MACHINE SERVICE BULLETIN #112

SUBJECT: Lock for Clear-out Mechanism "C" and "E" Models

DATE: March 6, 1931

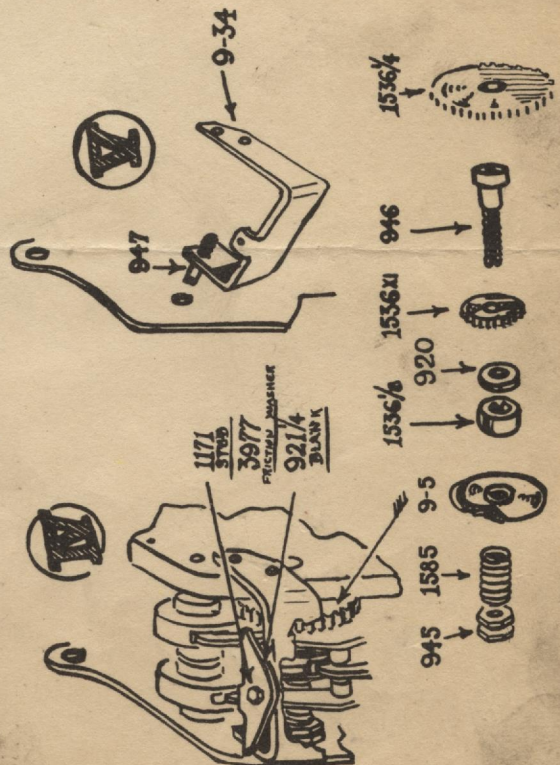
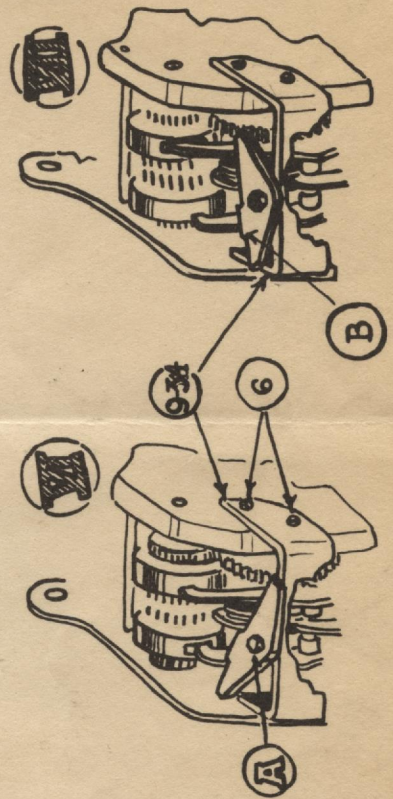
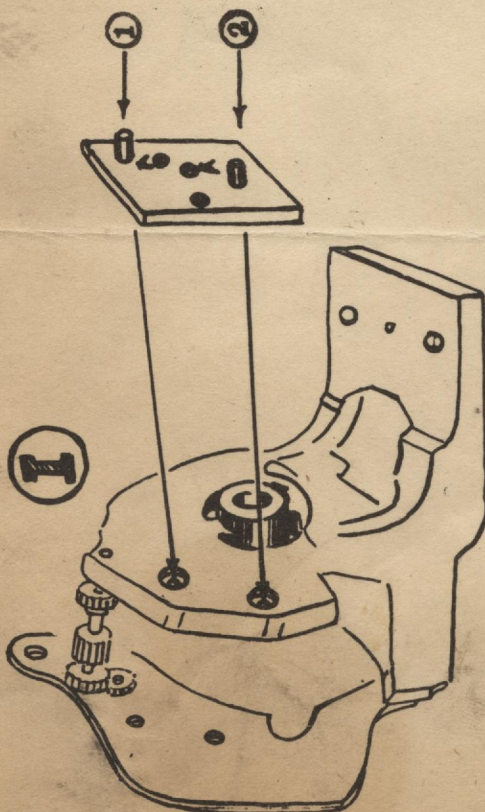
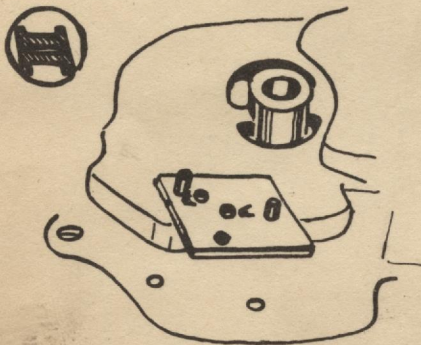
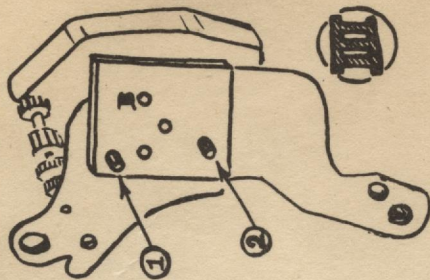
We are releasing, herewith, a sheet of prints together with the following instructions which illustrate and describe how to install a new lock for the "C" and "E" model machines for the purpose of preventing the possibility of the clear-out mechanism from locking up under rapid operation of the clear keys.

Place the drill jig on the motor bracket with the side of the jig marked A, out. Pins 1 and 2 of the jig should be located in the holes in the motor bracket as shown in figure 1 of the attached sketch. Drill holes A, through the motor bracket with a #32 drill. If the drill starts to chatter after the holes are started, remove the jig and complete the drilling without the jig, and thread these holes with a #6-40 tap.

Next, drill one hole in plate 1520 as shown in figure 3, with the side of the jig marked B, out, and with pins 1 and 2 of the jig located in the holes in the plate corresponding to the same holes in the motor bracket. This hole, B, should also be drilled with a #32 drill, but it is not to be tapped.

Replace parts C, D, E and F, plate 18, in their original position. In place of the original parts that were assembled on the lower 1552 shaft, parts shown in figure 4, are to be used. These are to be assembled as follows: First, the gear, 1536x1, goes over the left end of the 946 shaft with the smooth side of the gear away from the shoulder of the 946. Next, the fibre washer, 920, is assembled; then the collar, 1536-1/8, with the smooth side next to the fibre washer; then the clutch drum G, plate 18, which was removed from the bracket; then the spring, 1585, and the two lock nuts, 945. Assemble gear 1536 $\frac{1}{4}$ on the right end

Screw the 947 screw into the tapped hole in the left-hand end of the lock assembly, 9-34. This screw goes into the hole which was drilled in the 1520 plate. The bracket is fastened to the casting, with two #6 screws, into the holes that were drilled and tapped. (See figure 6). If a variation in the casting should cause a clearance between the casting and the assembly, 9-34, when the left end of the 9-34 is up against the 1520 plate, it will be necessary to pack thin washers between the 9-34 and the casting to take up this space before tightening screws #6. This is necessary to prevent the 9-34 from being sprung. However, if the variation is the other way, so that when the 9-34 is screwed tight against the casting, and the left-hand end is not tight against the plate, this can be taken care of by adjusting the eccentric stud, 1171, as 947 is long enough to act as a dowel.

The new lock functions in such a way that when either of the noses for clearing the upper or the lower dials is out, the other one is locked in. Stud A, figure 6, is an eccentric for adjustment. Figure 6 shows the position of the lock with the nose for clearing the lower dials out. Figure 7 shows the position of the lock with the nose for clearing the upper dials out. The lock should be adjusted so that when the upper dial nose is out, it rides up onto the high spot on the lock as shown. Also, when either nose is out, the locking piece should have a slight play. This may be tested by depressing each of the clear keys in turn and turning the driving lug on the end of the sun gear in a counter-clockwise direction, until the nose has released the clutch drums and the clutch drums have started to rotate. NOTE: If there is not enough movement in the eccentric adjustment "A" to take up any excessive play that may exist between the lock and the nose which is engaged, it will be necessary to adjust the nose which is not engaged farther away from the drum, as explained on Plate 22 of Machine Service Bulletin #108.

When the nose for the upper dial clutch comes out and starts to ride up on the high part of the locking piece, if it should catch, stone the corner slightly more round at point B, figure 7.
